## URGENT FIELD SAFETY NOTICE

**Date:** 18 November 2014  
**Attention:** TomoTherapy® System Medical Physicist  
**Affected Product:** Software versions 2.0.1/2.0.2/2.0.3 (Hi-Art 5.0.1/5.0.2/5.0.3)

- Urgent Field Safety Notice Concerning Dynamic Jaw Field Widths during Treatment

**Figure 1.** Screenshot from the Operator Station, showing the asymmetric 1.05cm beam that would be expected at the superior edge of the target.

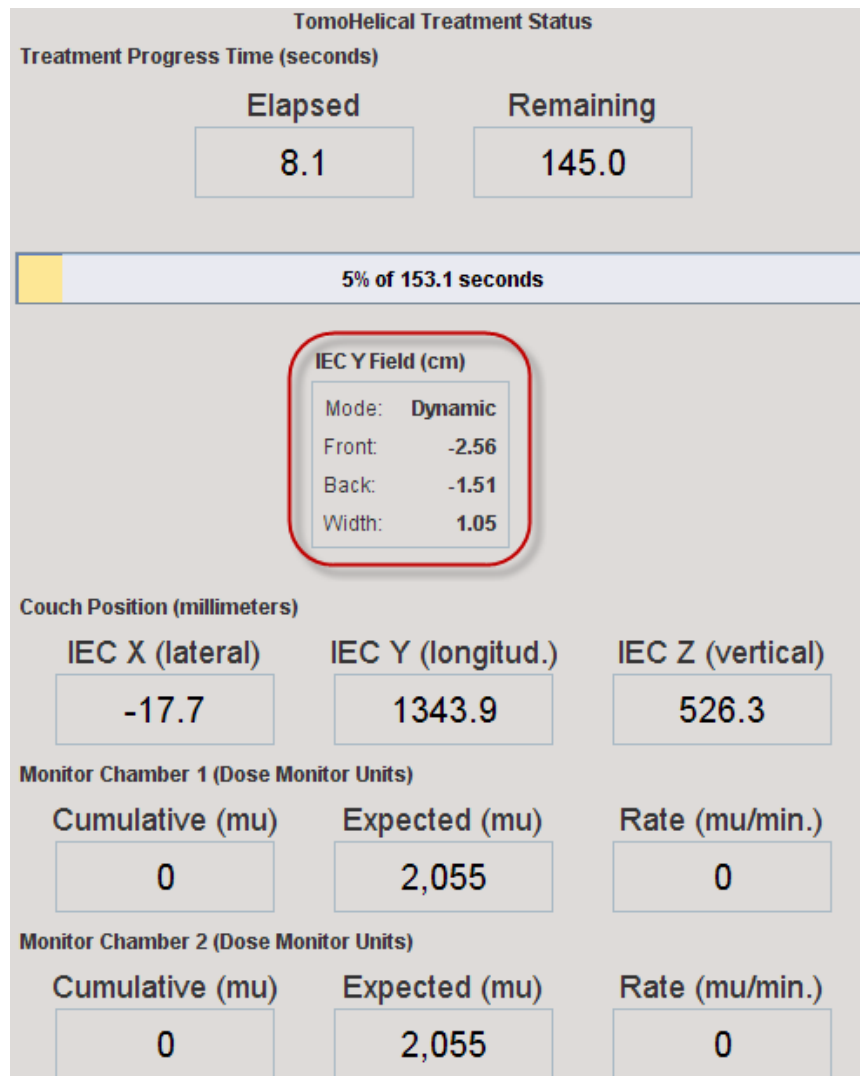
**Example:** For a dynamic jaw procedure, the field width will start at 1.05cm. In normal operation, this field width will increase until the maximum planned field width has been achieved. In the event that the issue above occurs, the field width will stay at 1.05cm for the remainder of the procedure, with the jaws in their maximally asymmetric position, as shown in the screenshot from the Operator Station in Figure 1, below.

If the issue described in this notice occurs, this field will not change during treatment.

- Replan these procedures using the static jaw delivery mode, or
- At the Operator Station (see Figure 1), monitor the **Width** for the **IEC Y Field (cm)** at the beginning of these procedures to ensure that it increases over time. If it does not increase, stop treatment and contact Accuray Customer Support for assistance.
